MONTGOMERY COUNTY DEPARTMENT OF PARK AND PLANNING

MCPB
Item # 3
1/17/2002

MEMORANDUM

DATE: January 11, 2002
TO: Montgomery County Board of Appeals
VIA: John Carter, Chief, Community-Based Planning *JC*
 Sue Edwards, I-270 Corridor, Team Leader
FROM: Nkosi Yearwood, Community-Based Planning *NY*
REVIEW TYPE: Special Exception
APPLYING FOR: Child Daycare Facility
APPLICANT: Kids N Care Learning Center
CASE NUMBER: S-2471
REVIEW BASIS: Chapter 59, Zoning Ordinance
ZONE: R-200
LOCATION: Dawson Farm Road and Mateney Hill Road
MASTER PLAN: Germantown Master Plan
FILING DATE: February 9, 2001
PLANNING BOARD: January 17, 2002
PUBLIC HEARING: January 28, 2002

A-2

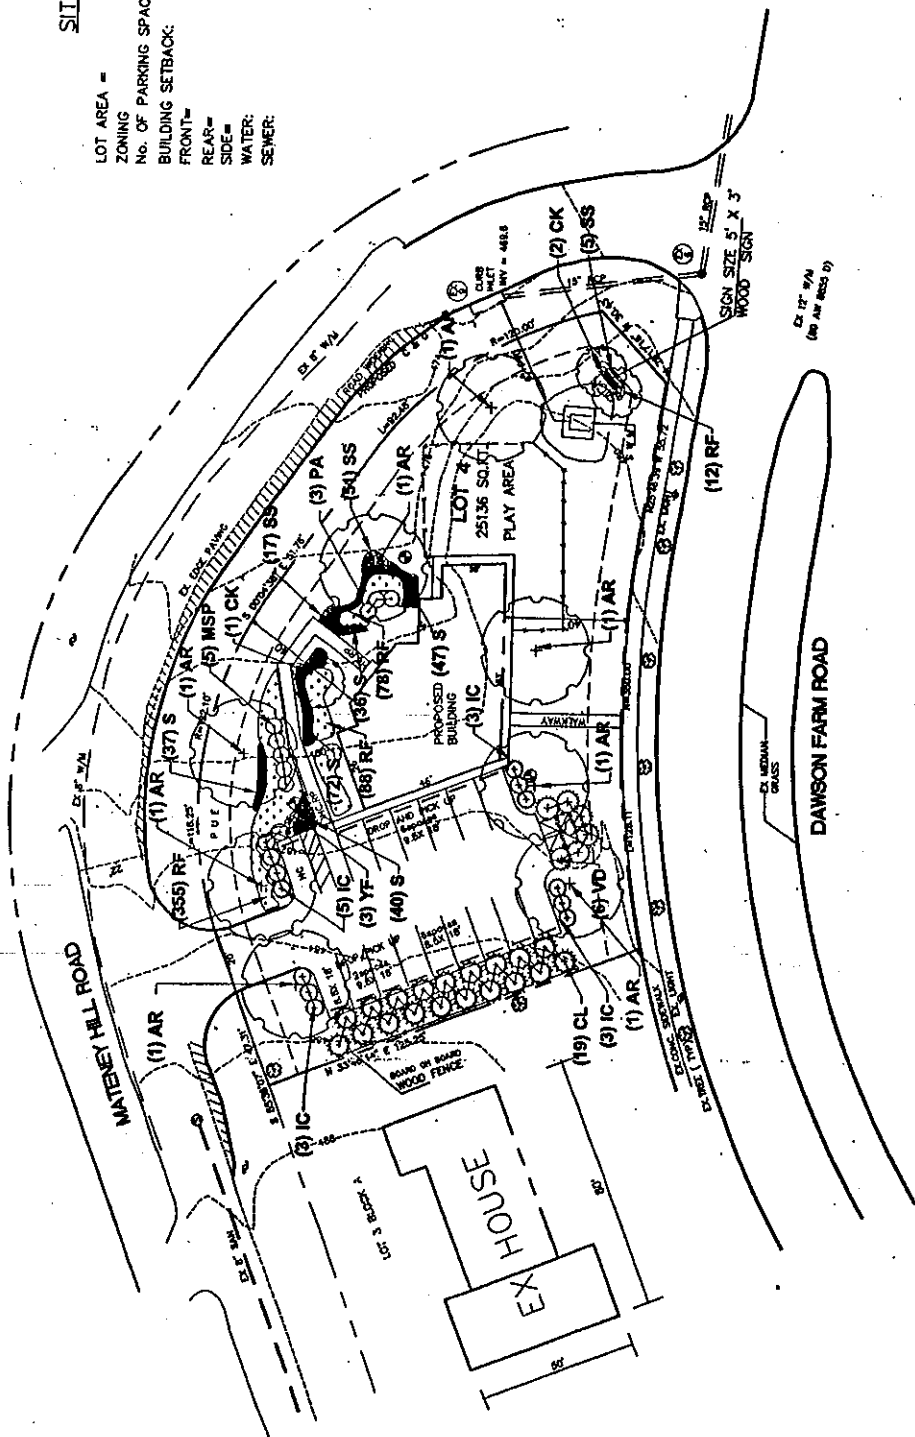
Based on the applicant's traffic survey of the parking activity during the drop-off and pick-up periods on a comparable facility, the proposed day-care center for 47 children will need 12 parking spaces for these activities. The site plan includes 15 parking spaces including one space for handicapped persons. Staff recommends that the site plan be revised to reduce the four parking spaces to three in the southern section since the proposed 7x19-foot space is not acceptable. A seven-foot-wide parking space is too narrow to park vehicles safely. Staff recommends that these three spaces and one parallel parking space be reserved for employee parking only, leaving eight parking spaces located across from the building for the drop-off and pick-up activities. This will reduce potential traffic conflicts during the drop-off and pick-up activities. It is staff's opinion that designating eight parking spaces away from the building for the use of drop-off and pick-up activities and employee parking spaces provides acceptable on-site traffic circulation, although the maneuver area, i.e., pulling out of parking spaces, is somewhat restricted on site.

Staff further recommends that Mateney Hill Road along the site frontage be widened to 20 feet of pavement from the 18 feet as shown on the site plan to provide a minimum two-lane roadway standard.

Staff's review indicates that the traffic issues, raised in our June 7, 2001 memorandum, related to the internal traffic circulation associated with the parking facility are now addressed on the revised site plan. The revised site plan also includes widening Mateney Hill Road to 20 feet of pavement in accordance with our recommendation.
